Account Name: McNeil Company
Homeowner Name: Schachne Residence
Job Address: 13651 Cumming St

Room: Kitchen

Room: Pantry

Room: Great Room

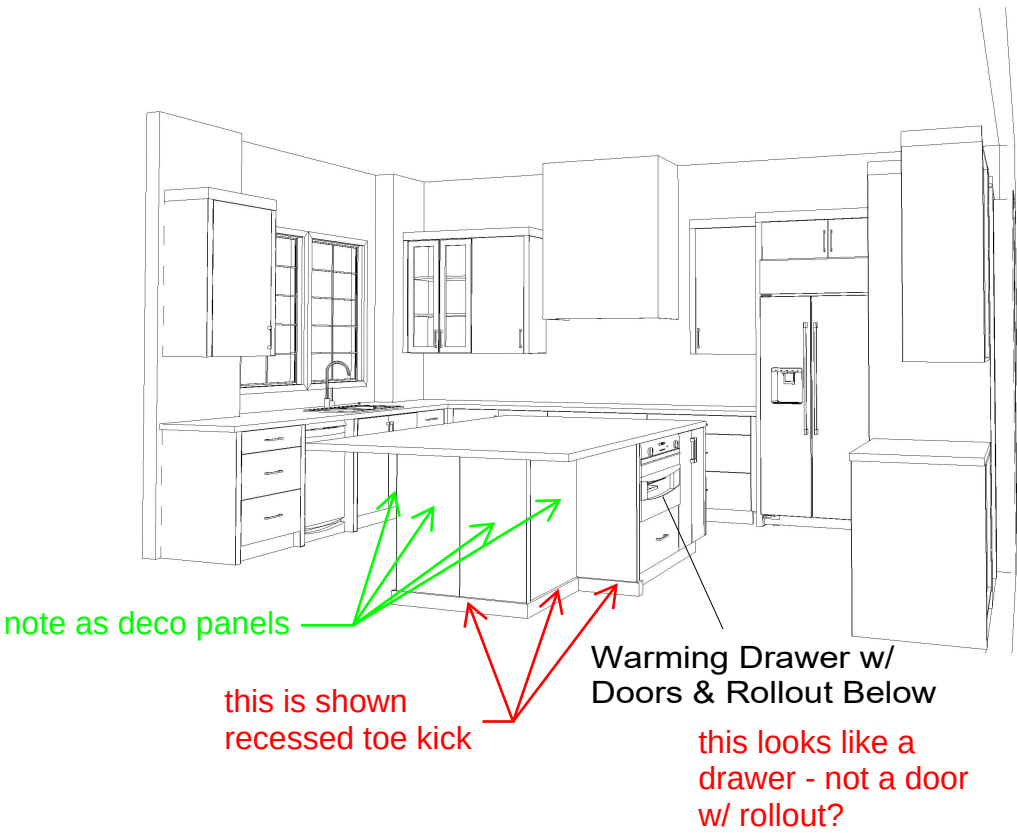
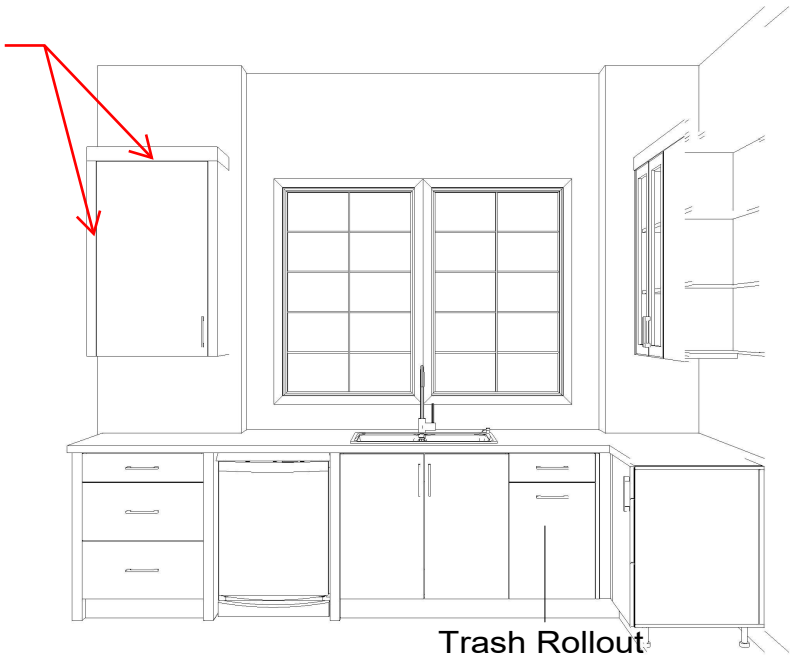
overall note - what is the height of the top band shown on most areas?

the top band and side fillers and frames should equal in size - the top looks taller

agree - mcneil elevations show 3/4" top and side fillers

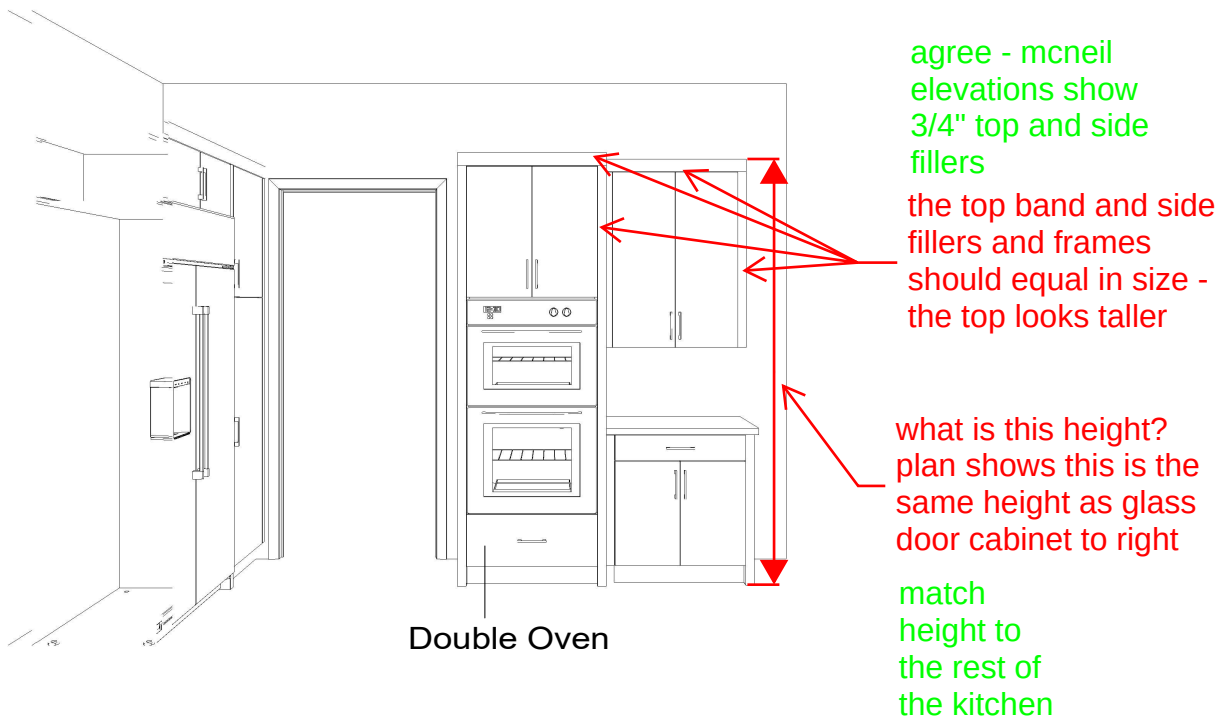
heights for everything for confirmation and for appliances

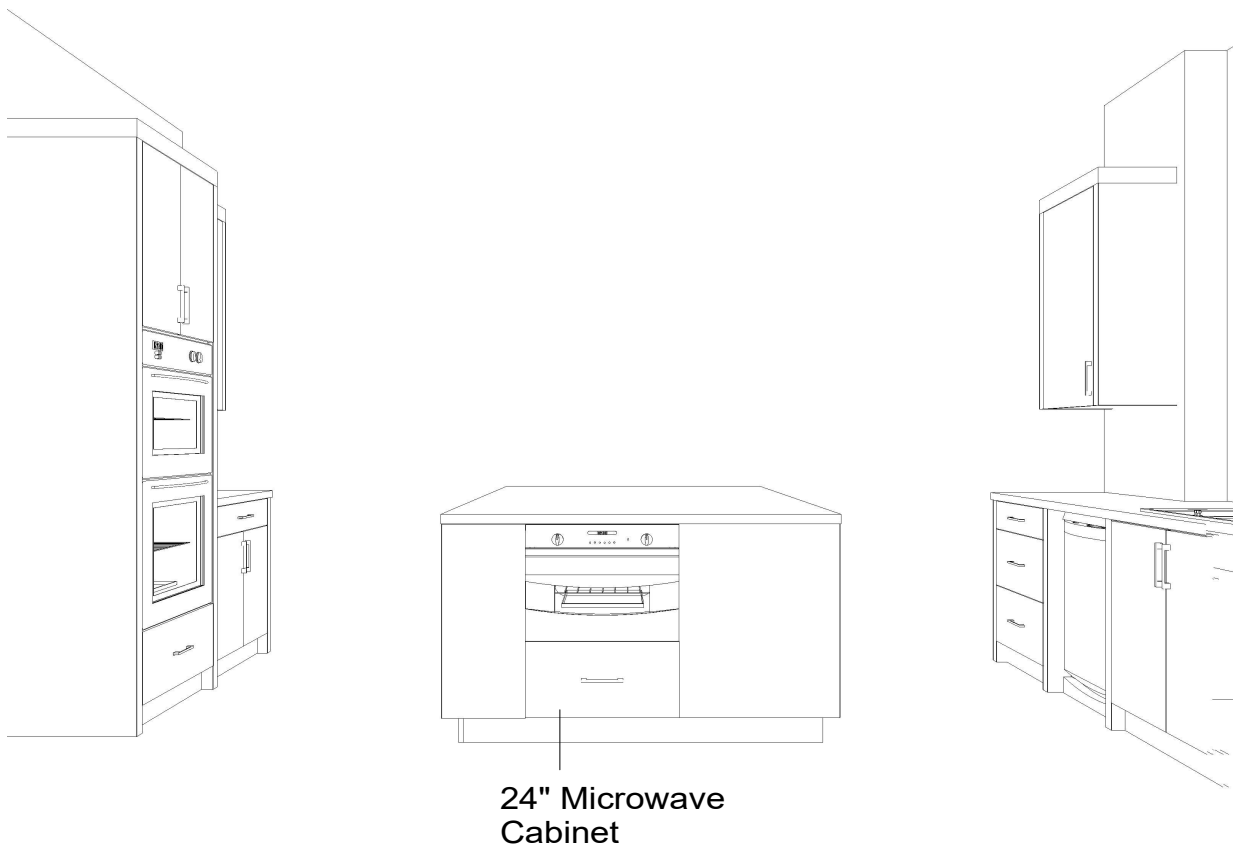
steel supports for
countertop overhang -
secured to structure
by ckf

dimensions?

note as (2) outlets in
back of this cabinet
for popup outlets

mcneil elevations
show this at 33"

confirm recessed
bottoms or routed
channels for LC
and plugmould

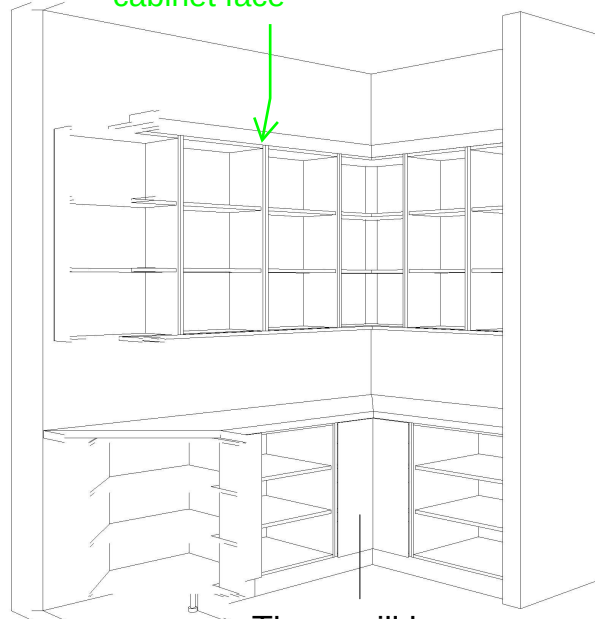
top band should be slightly proud of cabinet face

There will be no doors on this cabinet

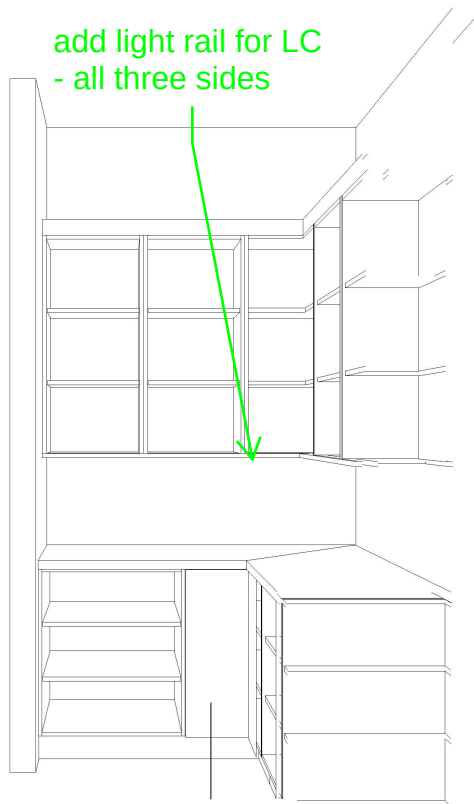
add light rail for LC
- all three sides

should we add space for step stool back in?

no - would add this in the broom closet

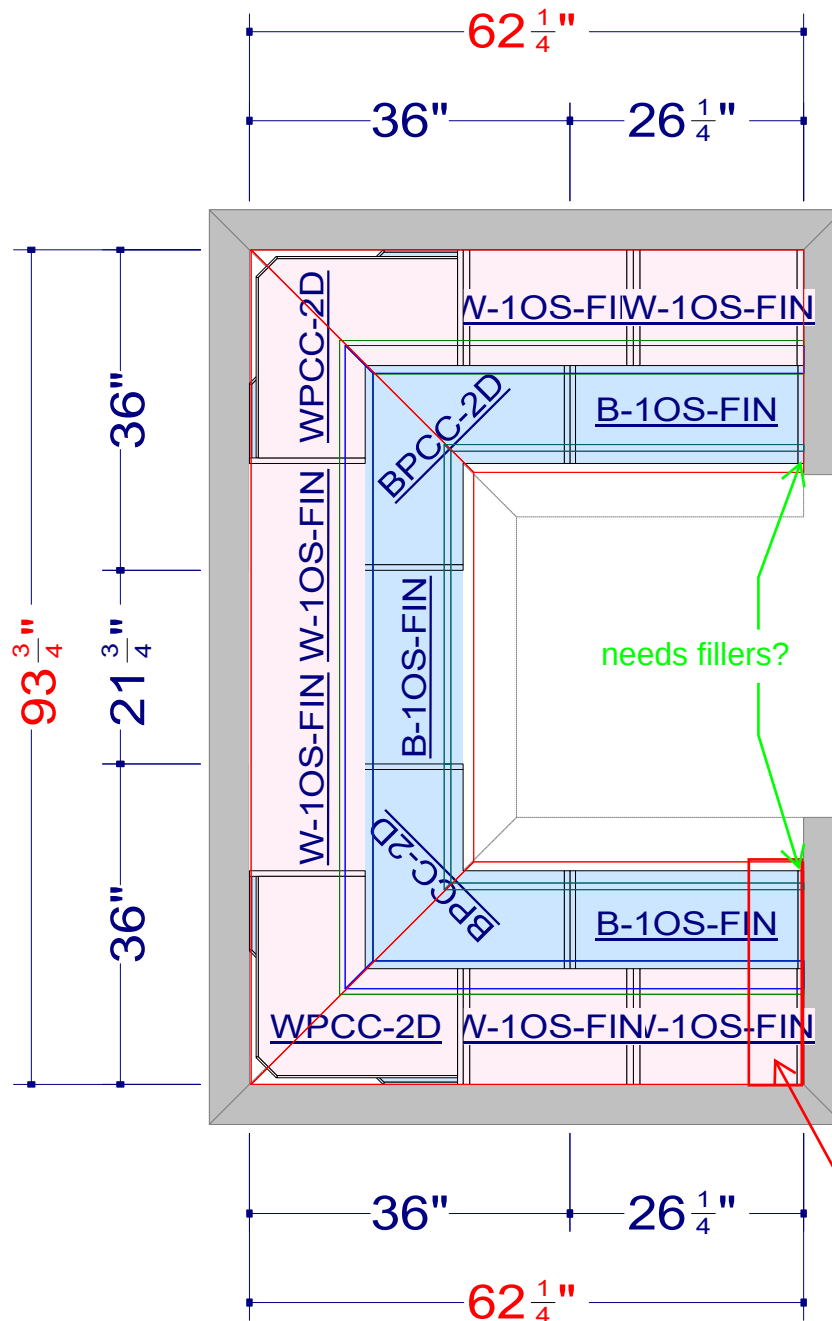
There will be no doors on this cabinet

will there be shelves?

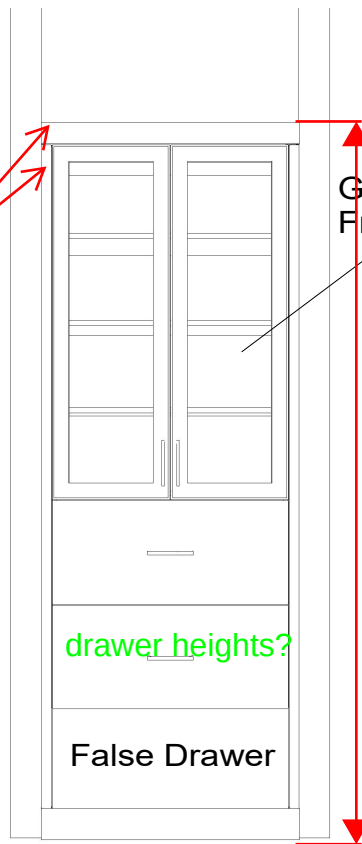
this frame is 1 1/2" all the way around - top matches sides

total height should be 7'-6"
confirm construction of cabinet to understand how to modify the bottom false drawer due to framing changes on site

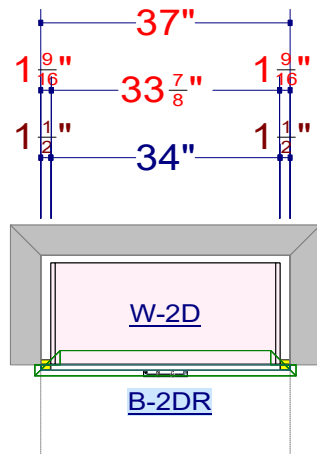
glass shelves by mcneil
mirrored back by mcneil

drawer heights?

what is height?

Attach 3/4" material to wall at floor as "toe kick".
Edgeband raw end. Fix loose drawer front above it.

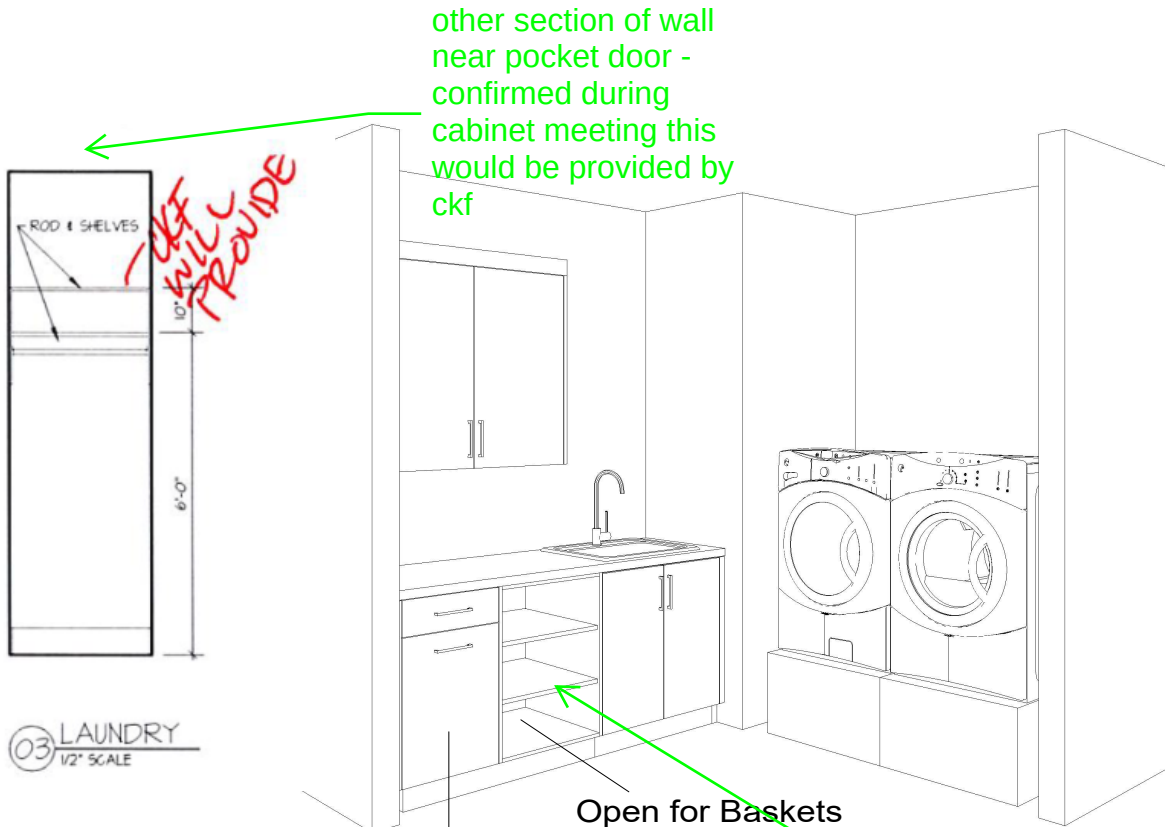
only (1) adjustable shelf for room for (2) baskets

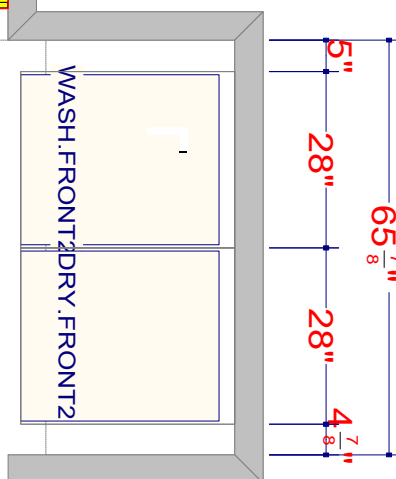
is this interior the vincenza oak?

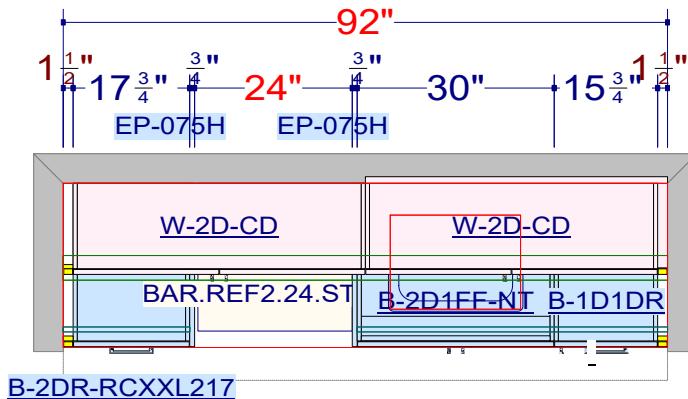
top band slightly
proud of cabinet face

since design changed
this looks more
balanced
agreed

Room: Basement Bar

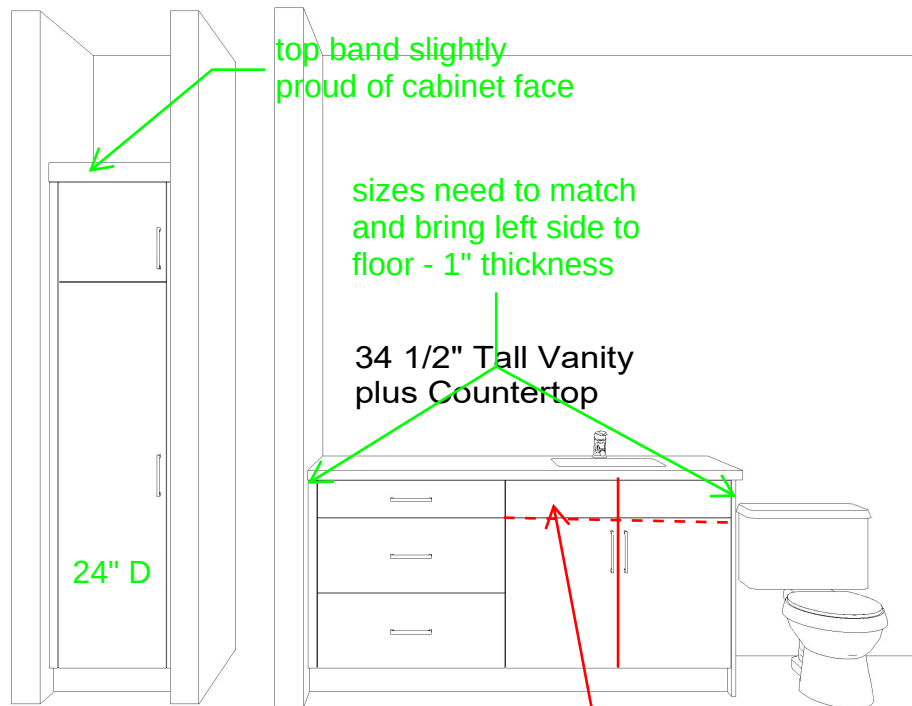
why did it change?
willow grey?
